Alexander Schleicher Segelflugzeugbau Poppenhausen/Wasserkuppe

Modification No. 9
Type L - 165 RhönlercheII
(US 7G6)

Name of Modification: Free pass of elevator cable at the control shaft.

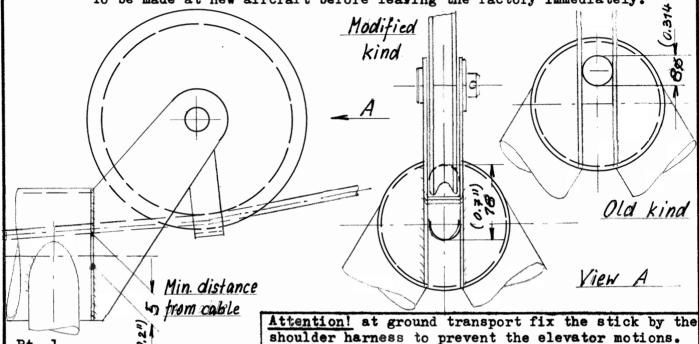
Cause: It is supposed a cable break is caused by friction on the pass through the rear end of the control shaft in front of the pulley.

a) Control the elevator cable for cracks and wear (Disconnect the connections and pull the cable through).

b) Sheck freegoing of the cable at the hole in the rear end of the control shaft, above and beneath the cable.

c) Control tension of cable. (cable must be not too slack, yet not too tight. Attent, high temperatures will cause slack cables).

Enlarge the hole to 18 + 20 mm, so that the minimum distance between cable and metal is 5 mm. To be used best a round file of 8 mm dia. The pulley is to be removed. Be carefully not to injure the cable. To be checked with build in pulley and cable in tension. Reinstall all safety pins etc.
